**CONTRACT DOCUMENTS & TECHNICAL SPECIFICATIONS
ADDENDUM NO. 1**

**DELAWARE BAYSHORE BYWAY
COOPER-CROSS WILDLIFE VIEWING ENHANCEMENTS
CONTRACT NO. FW-1-15**

Date of Issue: November 6, 2017

S-6

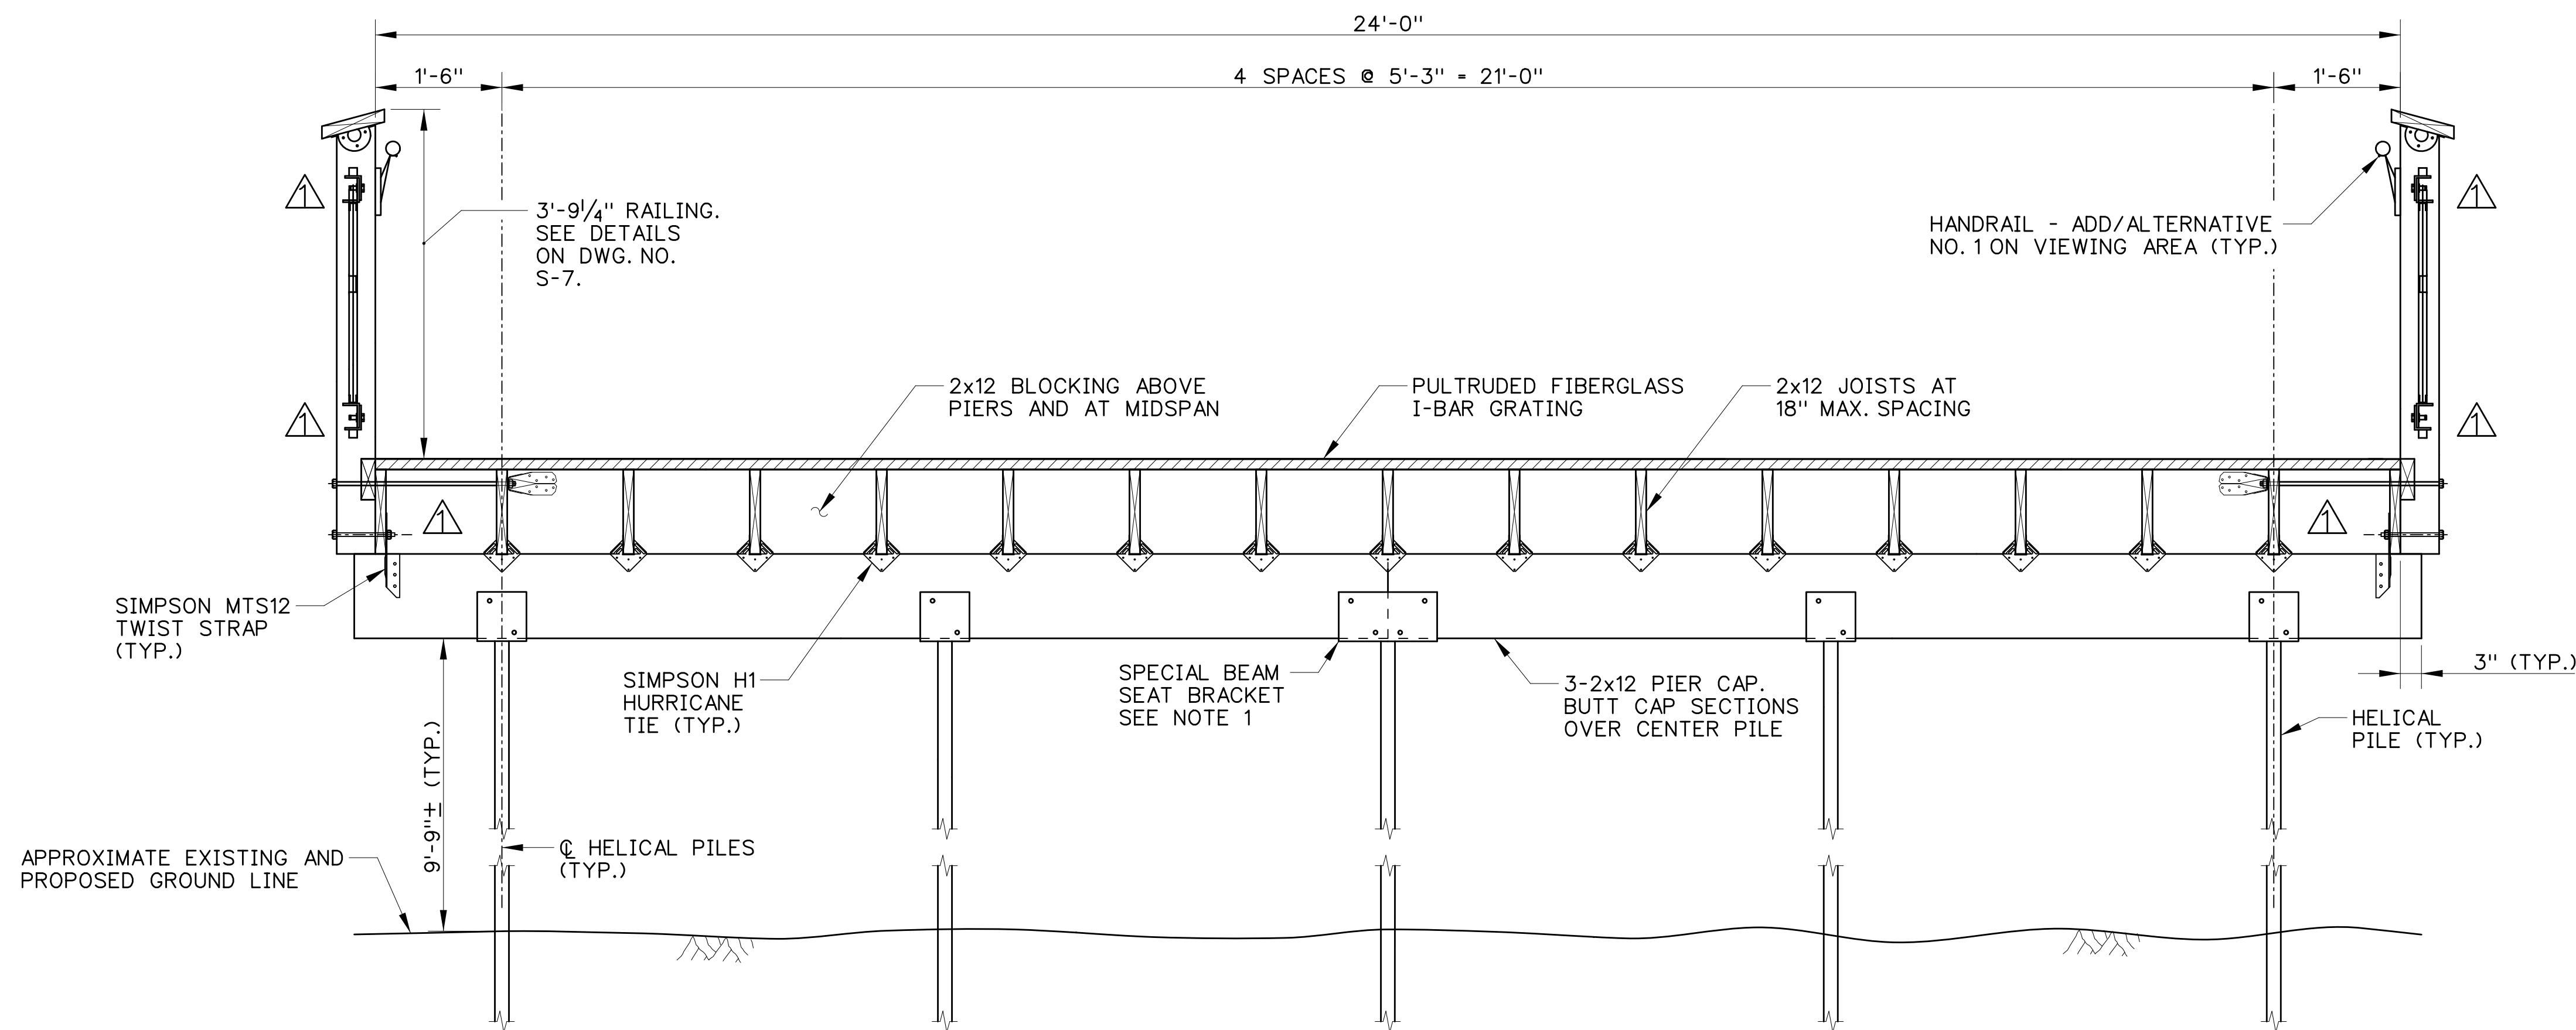
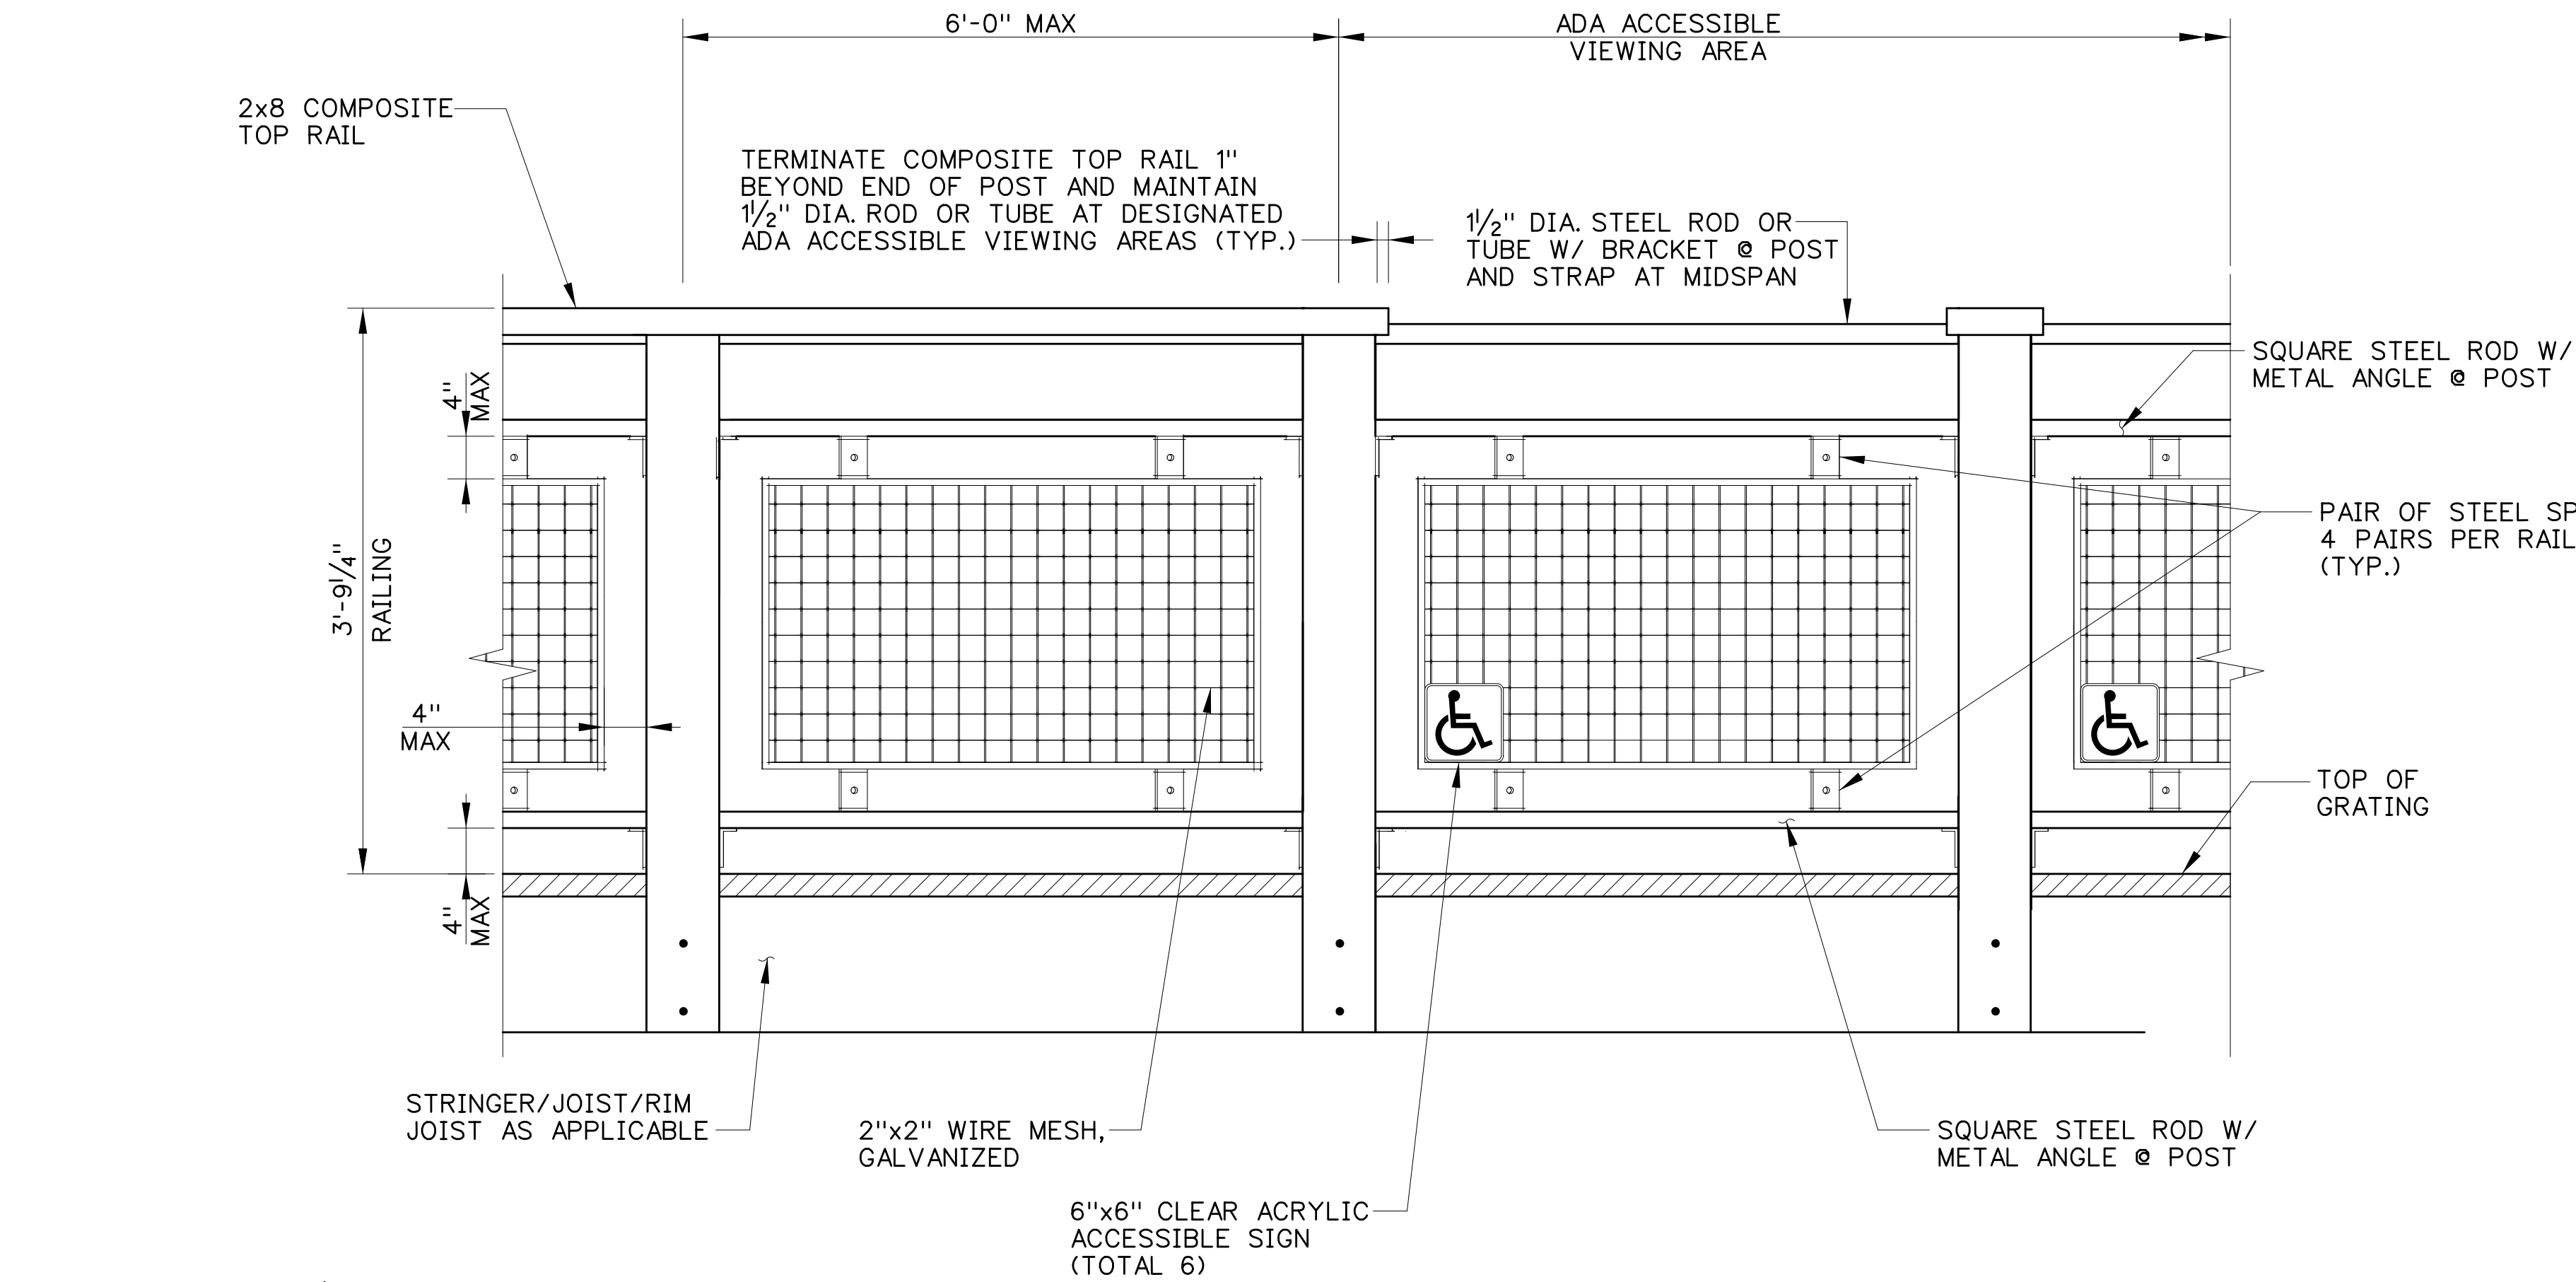
1. **Drawing S-4, S-6, S-7:** Revised direction of angles on the railing.

DATE: 11/3/17
DESCRIPTION: REVISED RAILING

S-7

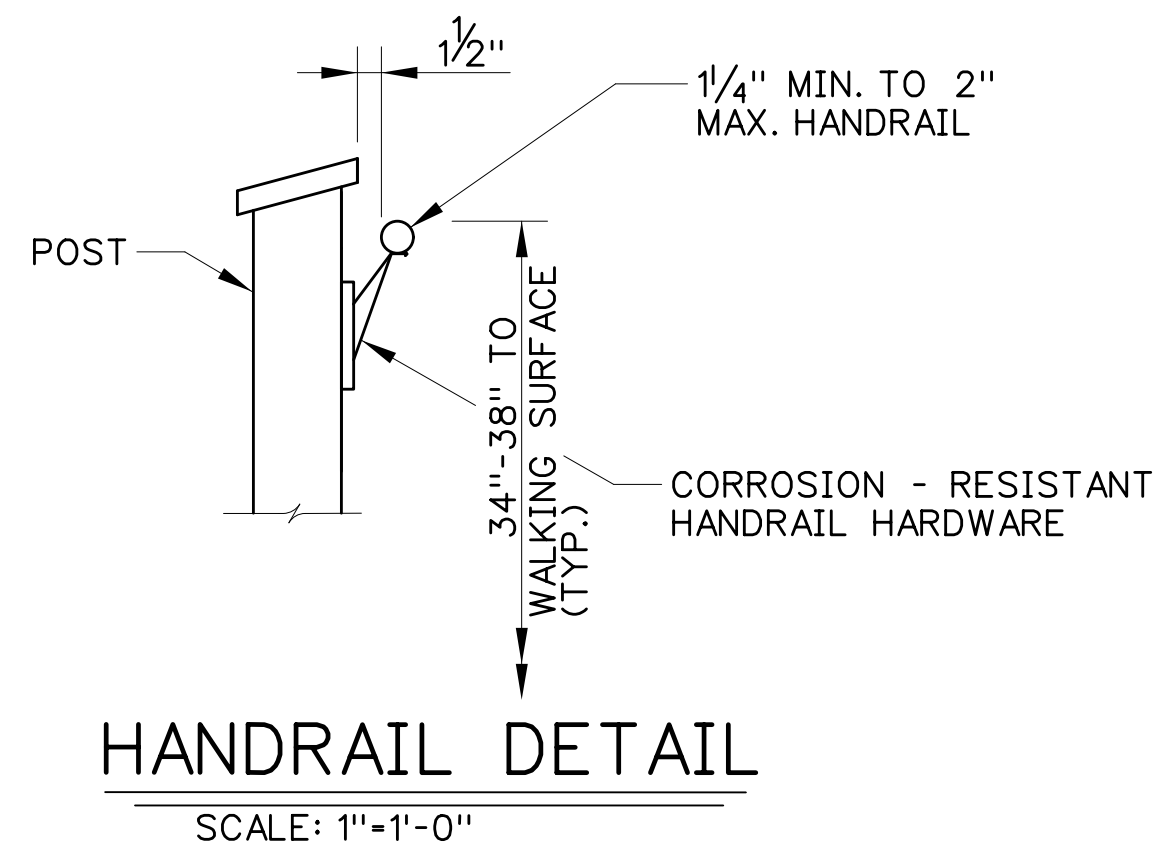
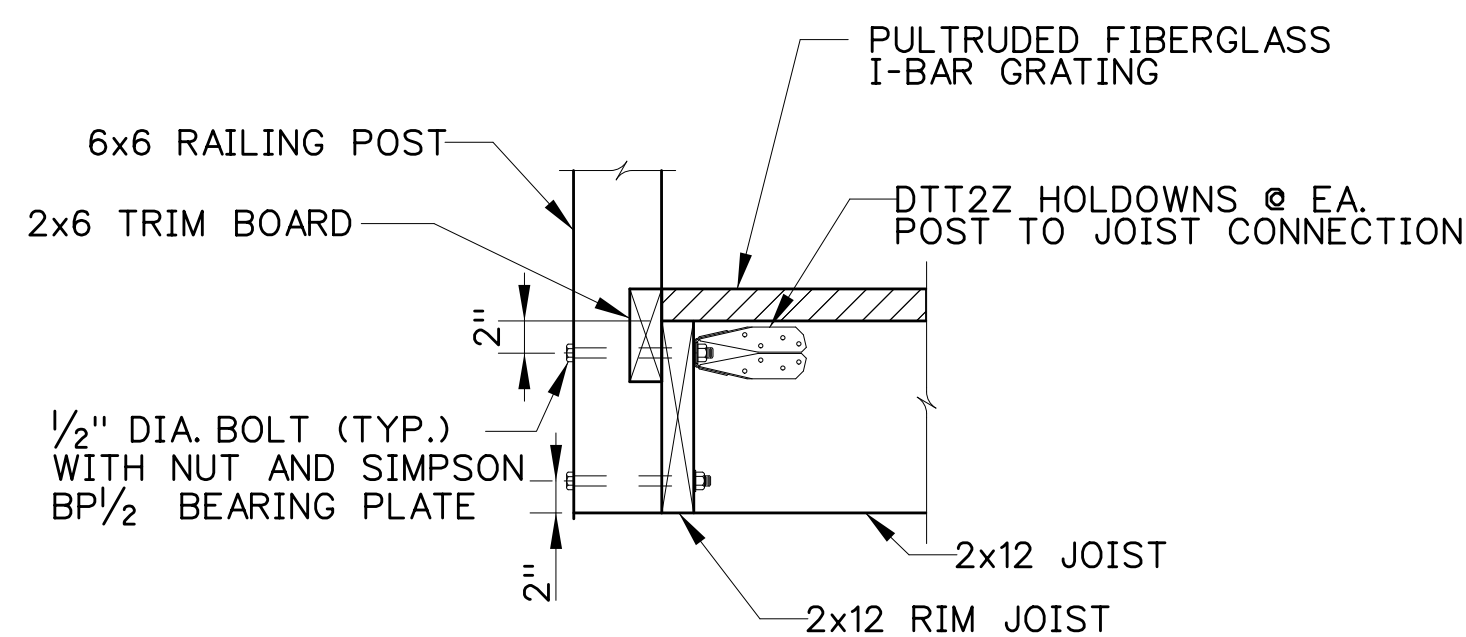
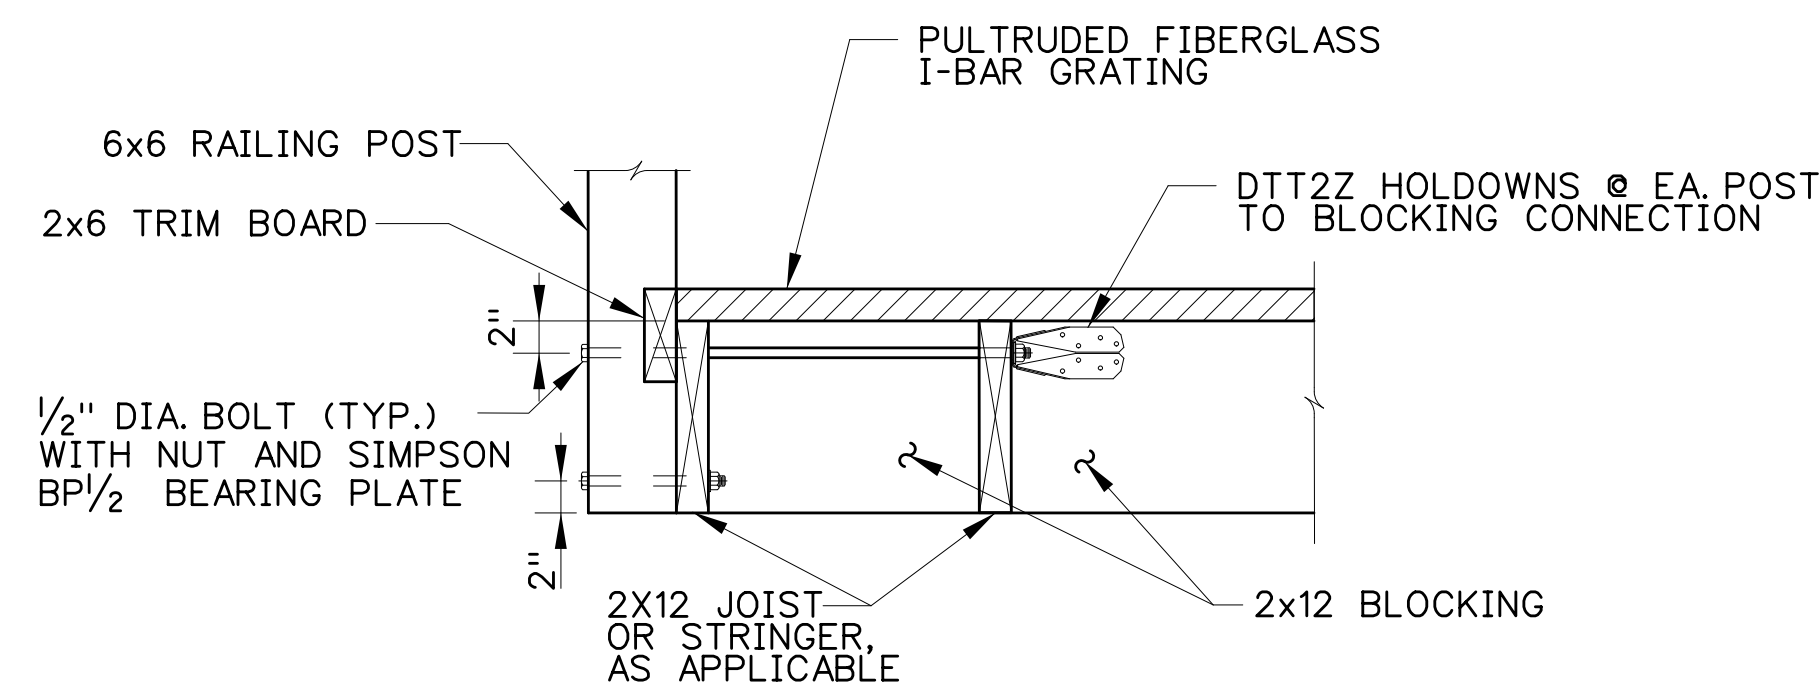
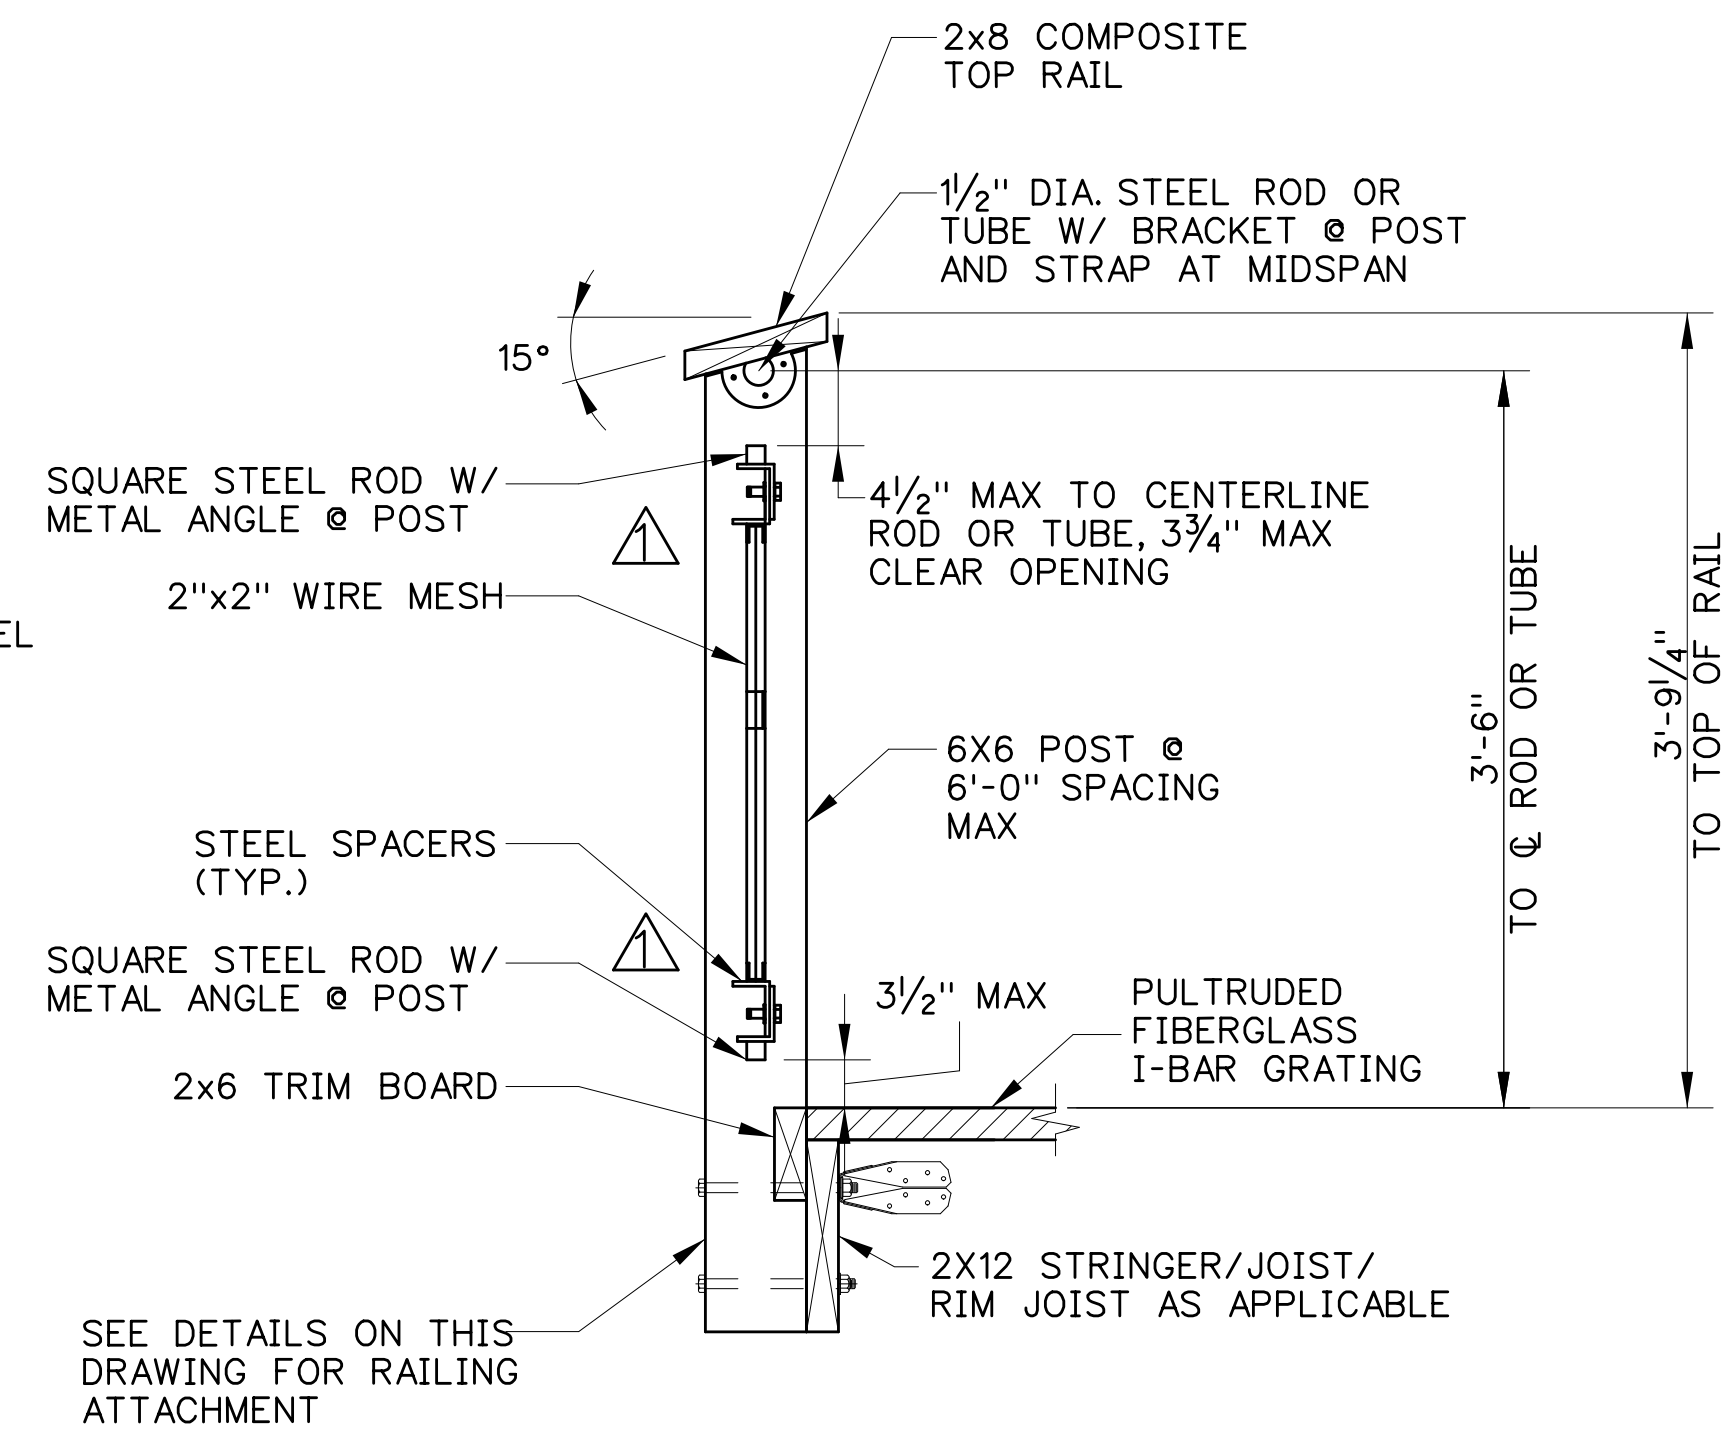
11/3/17 REVISED RAILING
